PQ DOCUMENTS

Revoren Group Brochure

Revoren Executed / Current Projects Project Approvals

DUBAI SOUTH / AL BURJ Engineering Consultants / LOOTAH ENGINEERING AND CONSTRUCTION	DESIGN & BUILD OF THE NOLUS	SHOP DRAWING SUBMITTAL	
		Reference No.	BP159-LEC-SHD-CIV-000020
	RFP 159/BP/21 in Bussines Park of Dubai South	Rev. No	1
		Date Submitted	28-Dec-21
Originator of Submittal	LOOTAH ENGINEERING AND CONSTRUCTION LLC	No. of hardcopies	Soft copy

DATE
DRAWN BY	MUSTHAFA	05-12-2021
CHECKED BY	SARA	
APPROVED BY	SARA	
SCALE	A1 / AS SHOWN	
DRAWING NUMBER		REV
BP159-LEC-SHD-CIV-000038-PDF		0

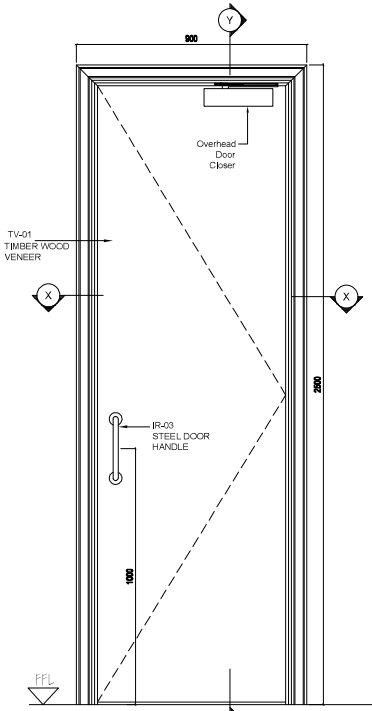
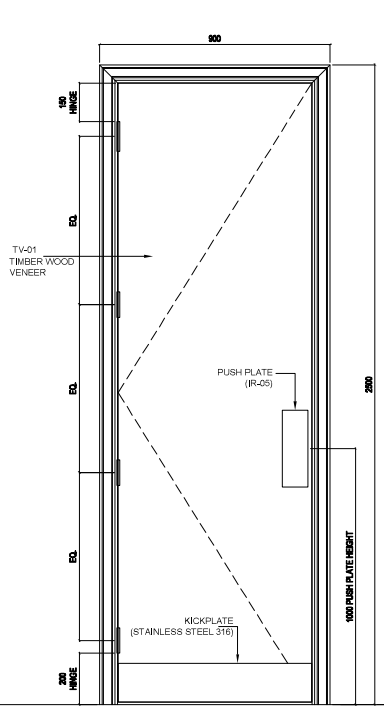
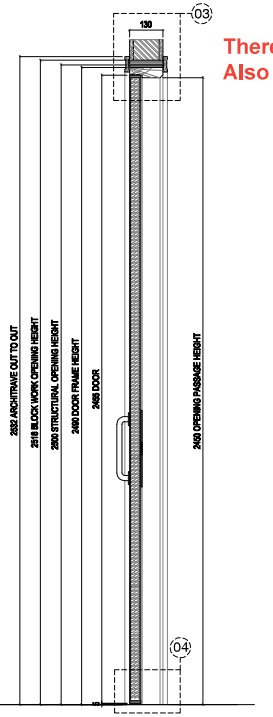
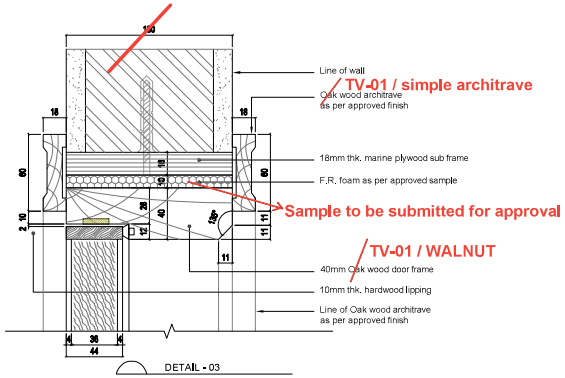
1.) (Architrave) to be simple / plane see attached photo.

There is no block shoulder (Refer to Detailed drawings Door D2)
Also check site condition

Simple Architrave is required

DATE
DRAWN BY	MUSTHAFA	04-01-2022
CHECKED BY	SARA	
APPROVED BY	SARA	
SCALE	A1 / AS SHOWN	
DRAWING NUMBER	BP159-LEC-SHD-CIV-000077	REV 0

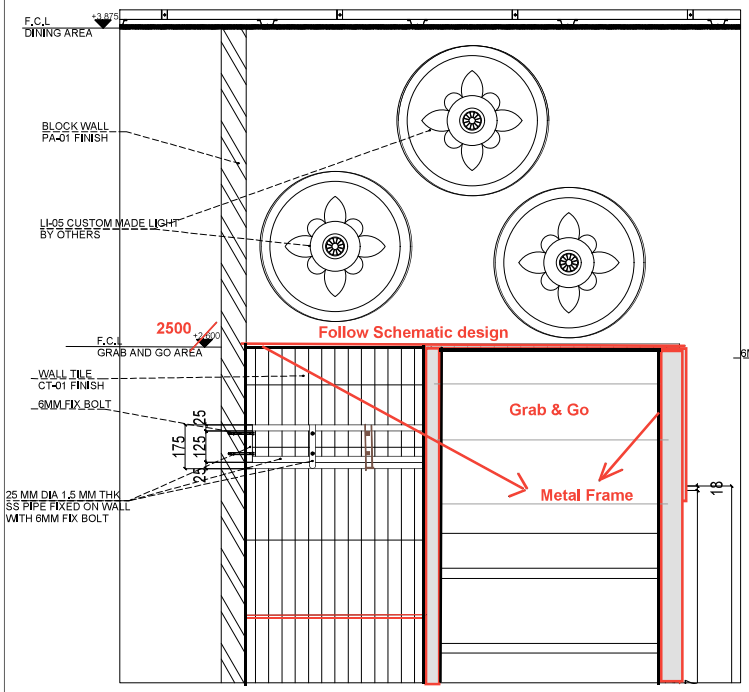
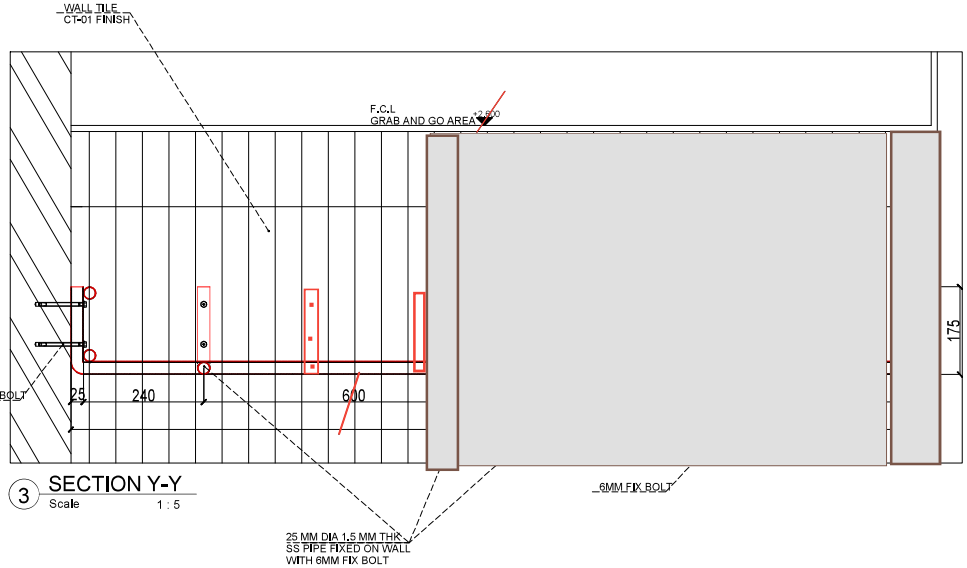
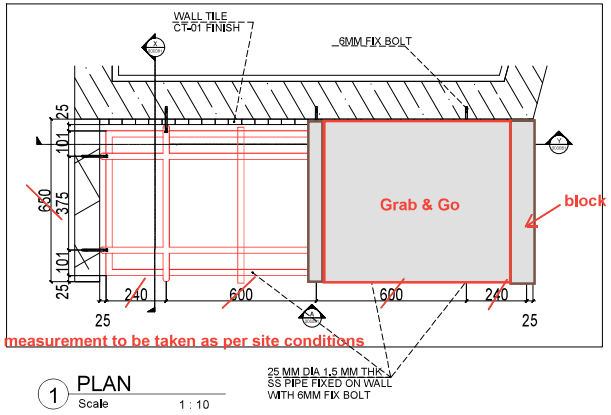
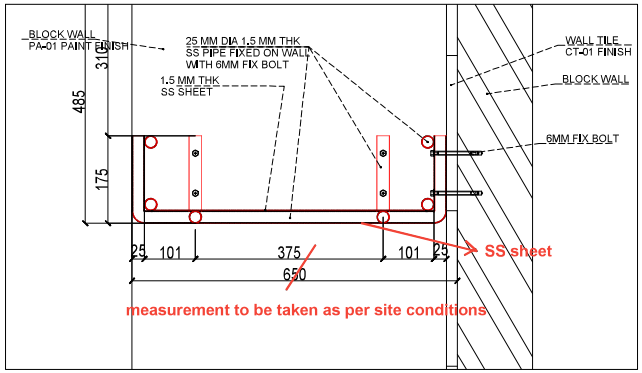
Refer to Client comments on shop drawings of (Grab & Go) Ref. No. BP159-LEC-SHD-CIV-000028

1 -- BOH KITCHEN LAYOUT @ GROUND FLOOR
SC. 1:25

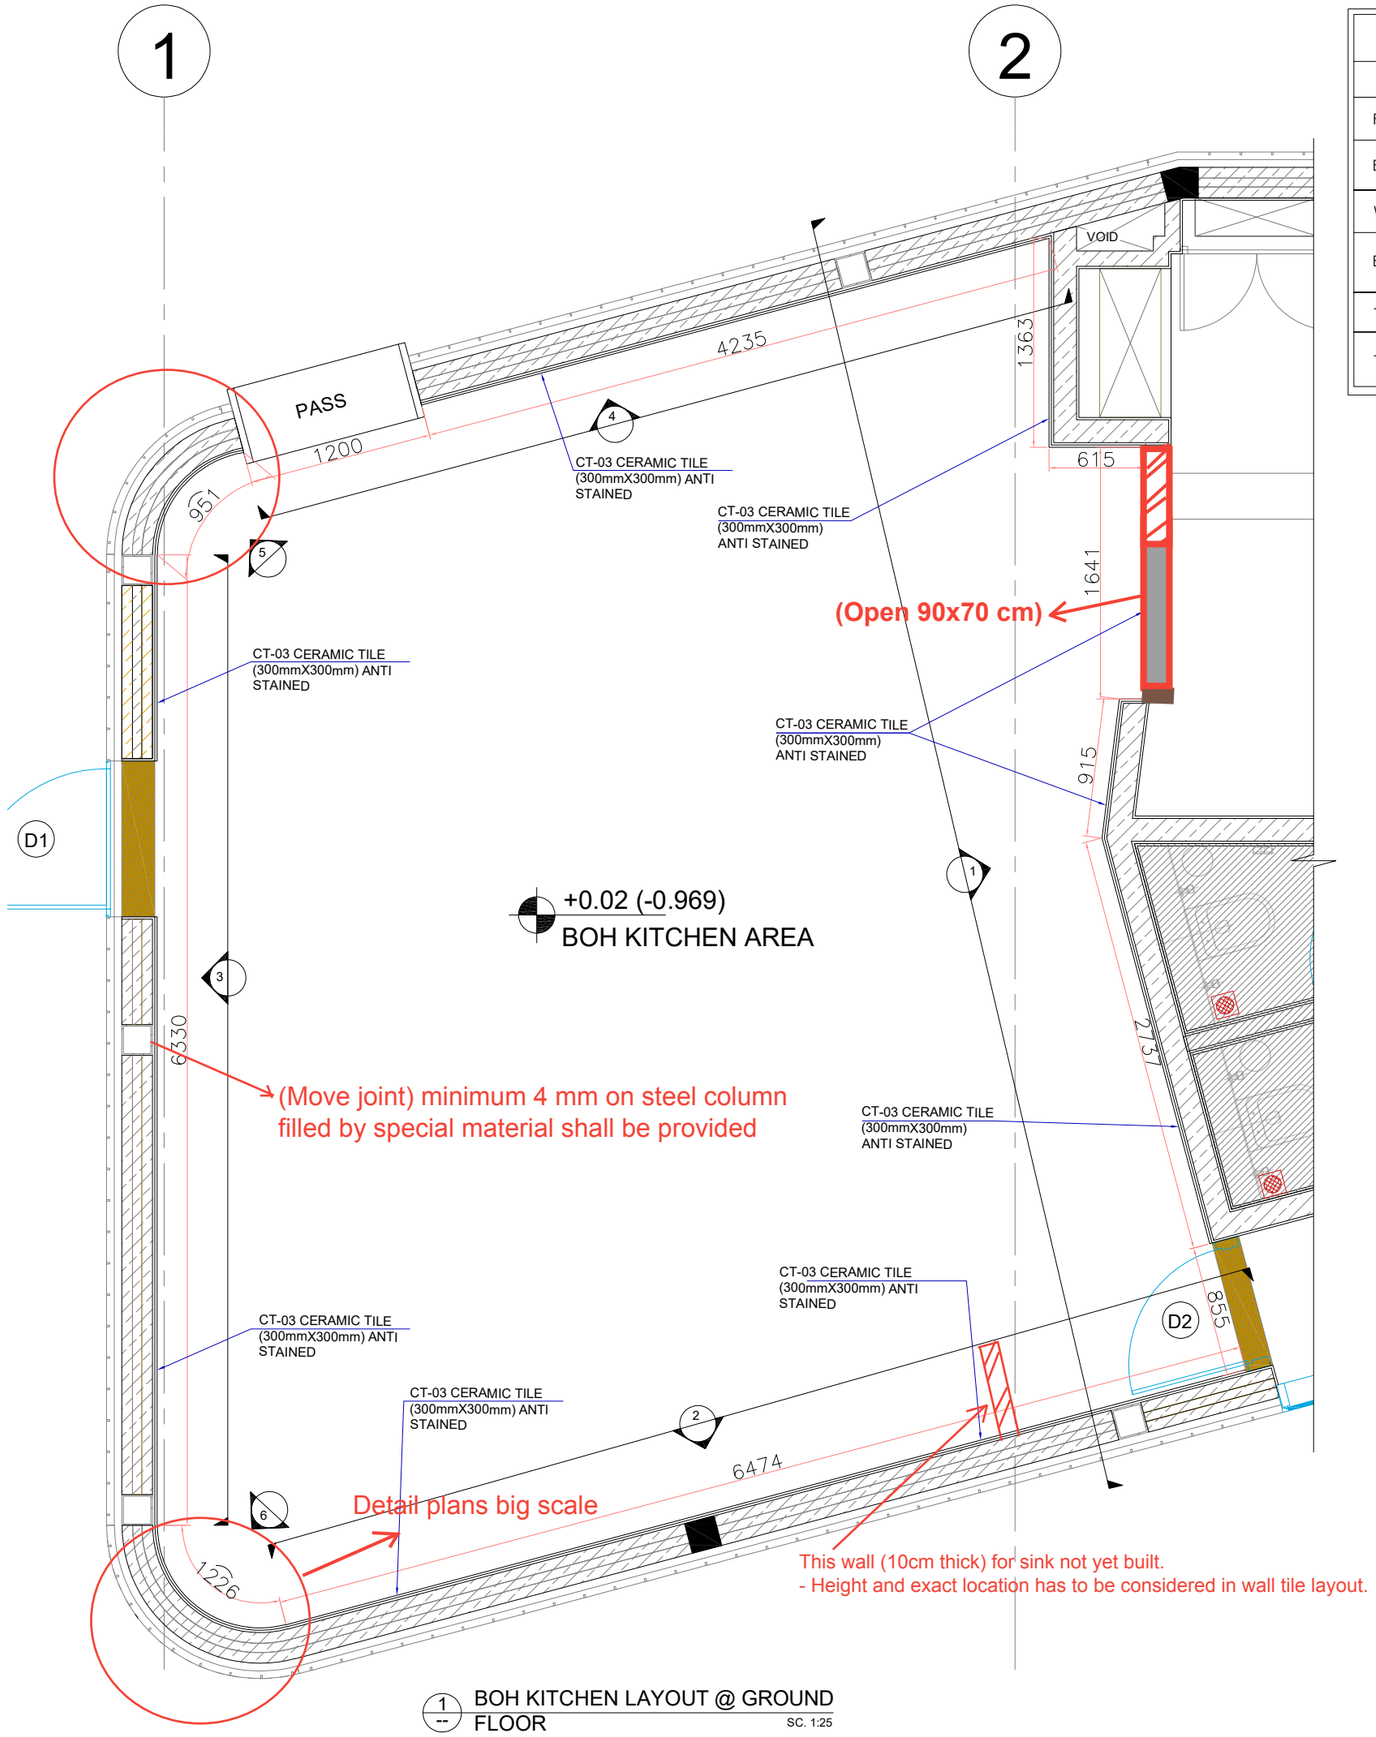
- **Small cut piece not acceptable.**
- **Open size (90 x 70 cm) between kitchen and bar to be added and consider into shop drawings.**
- **block wall for sink to be added and consider into shop drawings.**
- **Detail plans big scale at the 2 curves to be provided, to make sure that tile 30x30cm can round, and not need visable as a sigmented.**
- **S.O.P at some elevations are not clear.**
- Just make sure corner profile is there .
- Termination at door and window are provided
- Tiles should go above the ceiling with shadow gap detail

PROJECT NO:	DATE	DRAWING NO	REV
BP159	12.12.2021	BP159-LEC-SHD-CIV-000039-PDF	R0

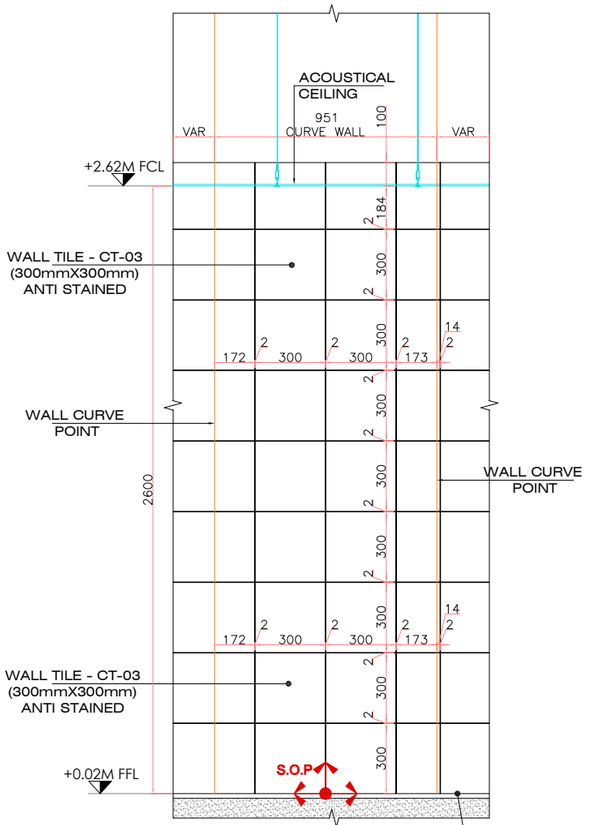
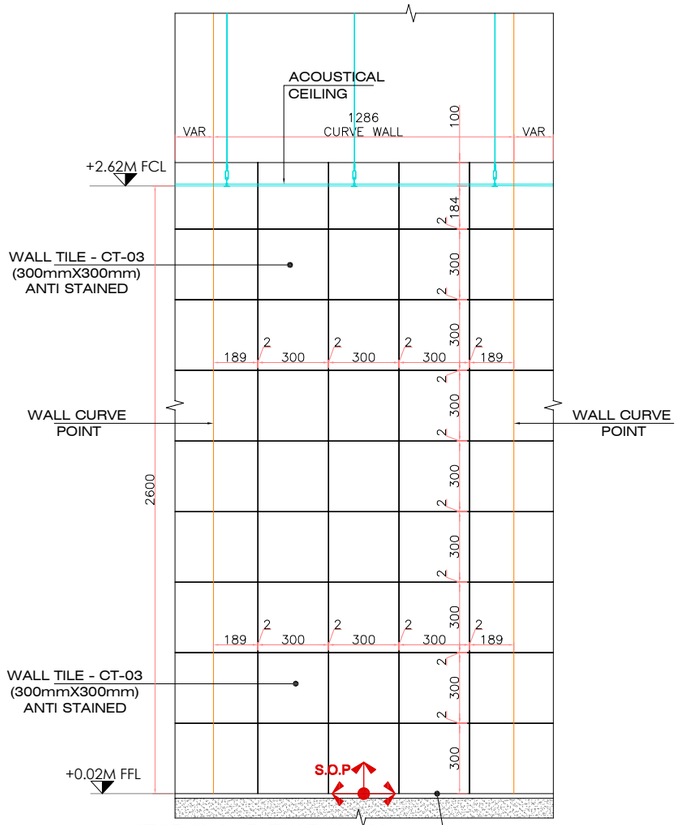
Detail plans big scale at the 2 curves to be provided.
to make sure that tile 30x30cm can round, and not need visable as a sigmented.

PROJECT NO:	DATE	DRAWING NO	REV
BP159	06.12.2021	BP159-LEC-SHD-CIV-000036-PDF	R0

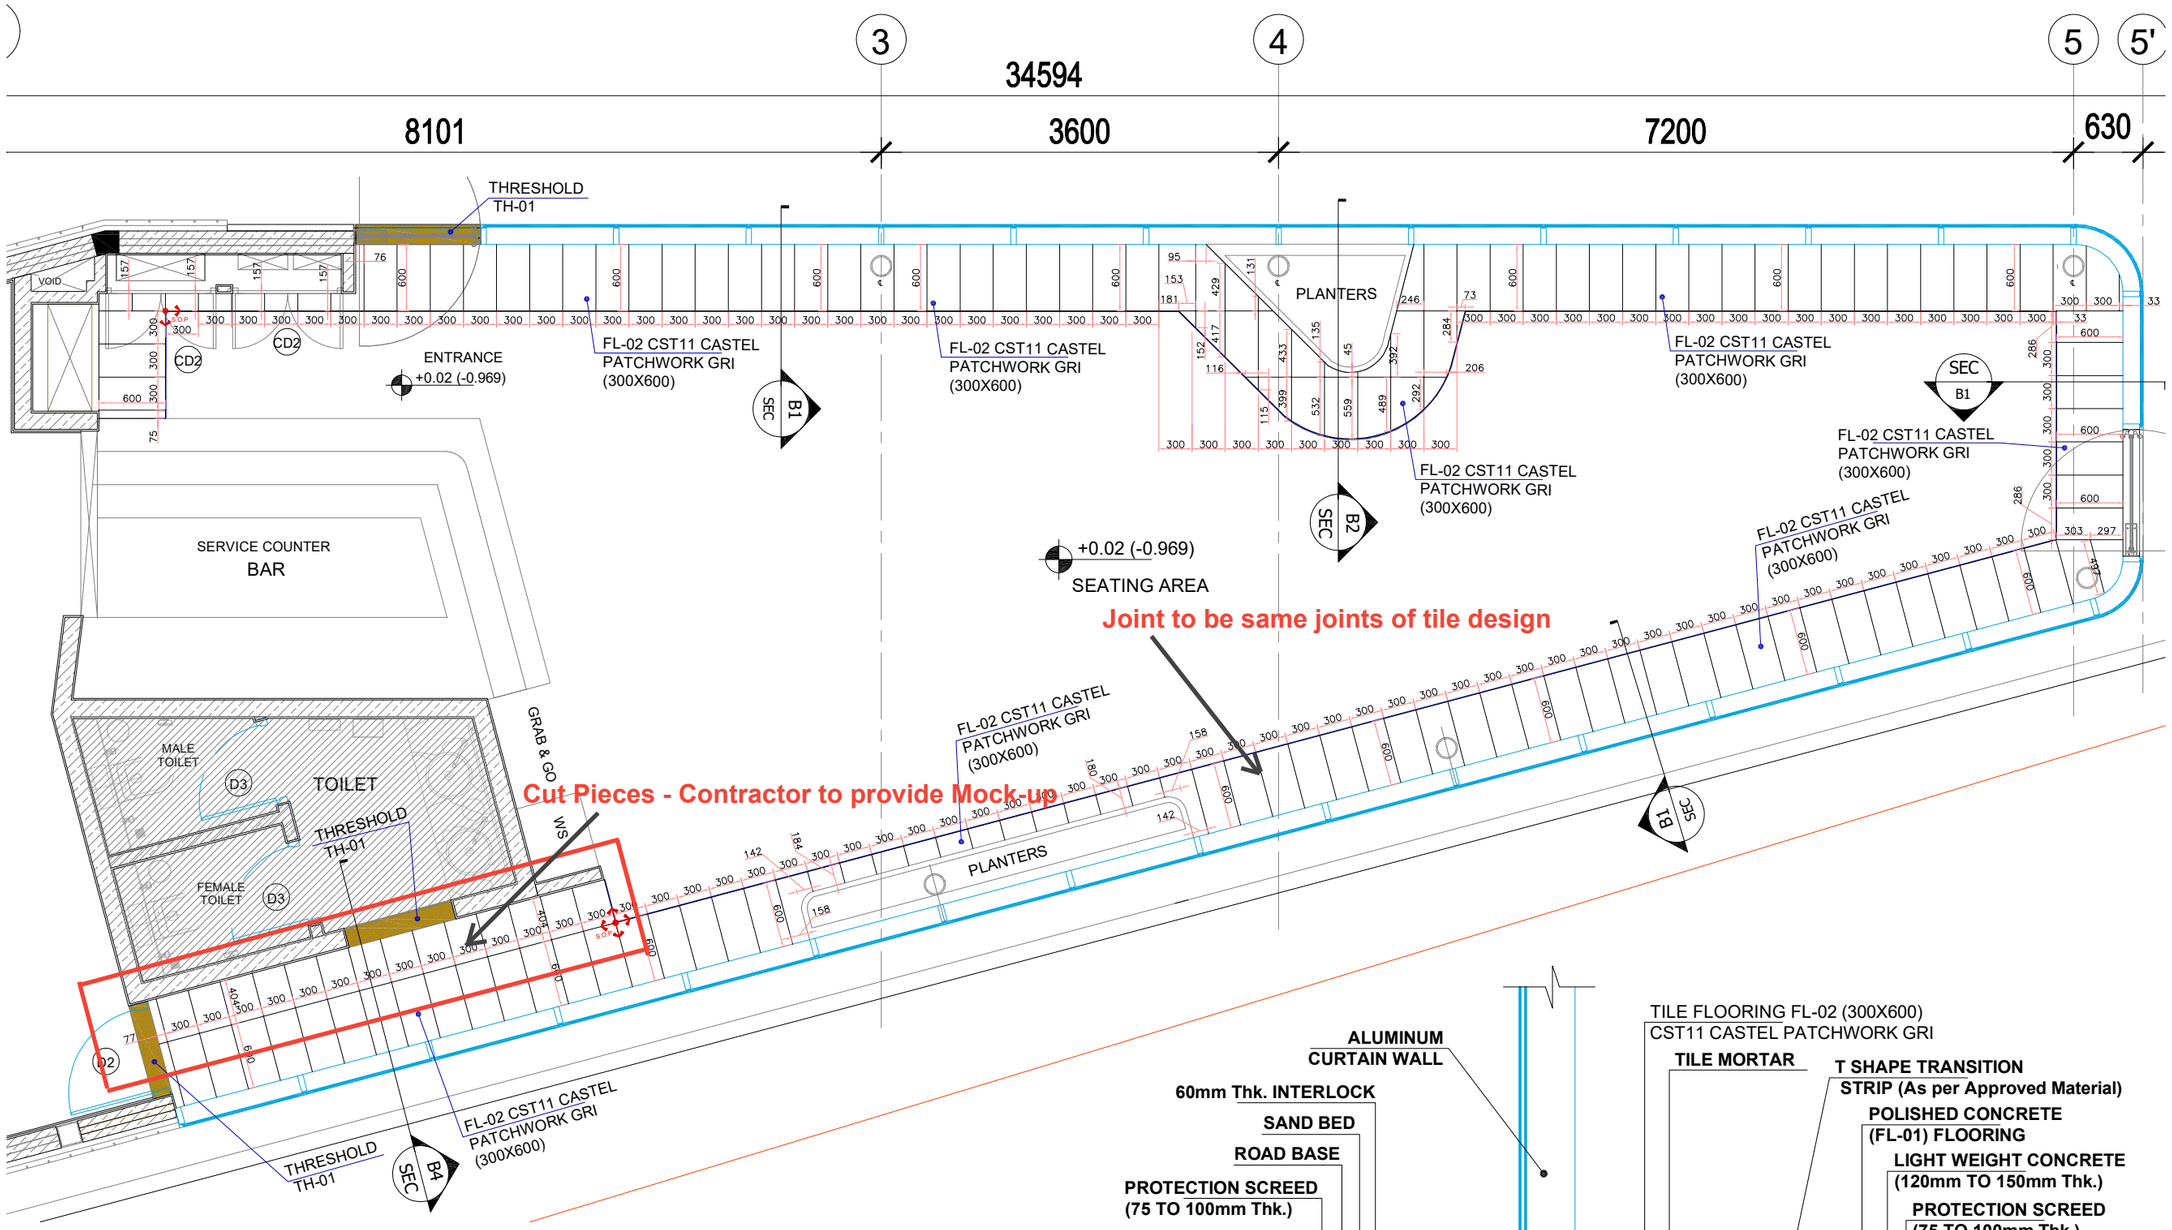
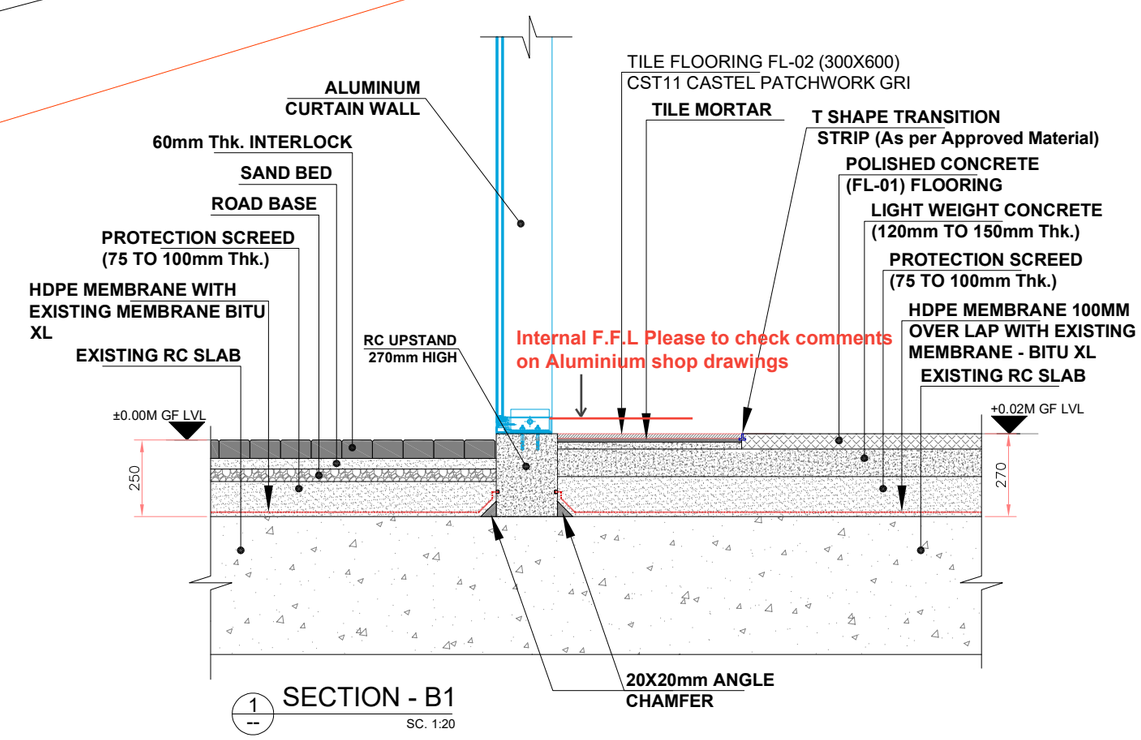
1.) See comments on the below drawings
2.) cut pieces as highlighted on drawing need to provide mock-up for approval.
3. Joints betwee tiles to be same joints on tiles designs.

DATE
DRAWN BY	MUSTHAFA	19-12-2021
CHECKED BY	SARA	
APPROVED BY	SARA	
SCALE	A1 / AS SHOWN	
DRAWING NUMBER		REV
BP159-LEC-SHD-CIV-000063		0

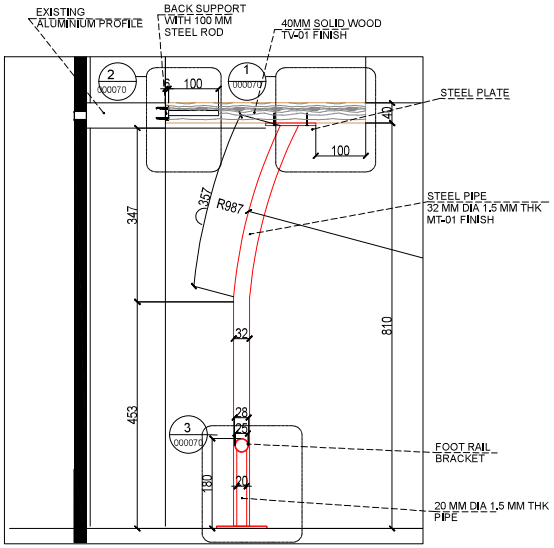
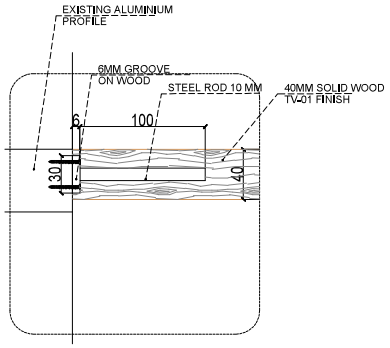
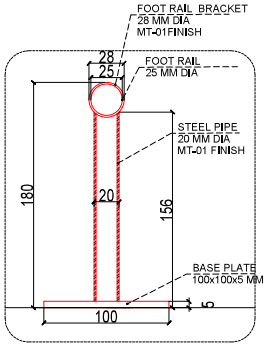
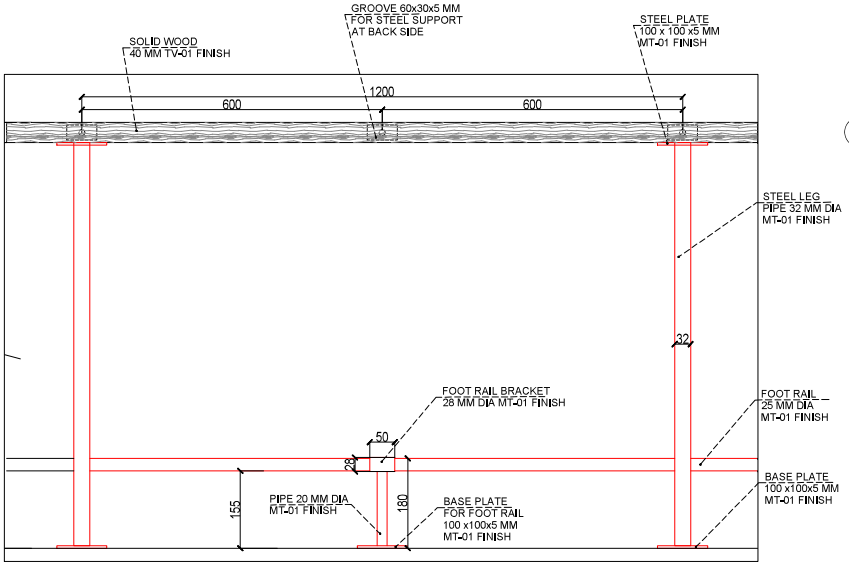
Rounded Base Plate Diameter 100 MM / SS MT-01 Finish
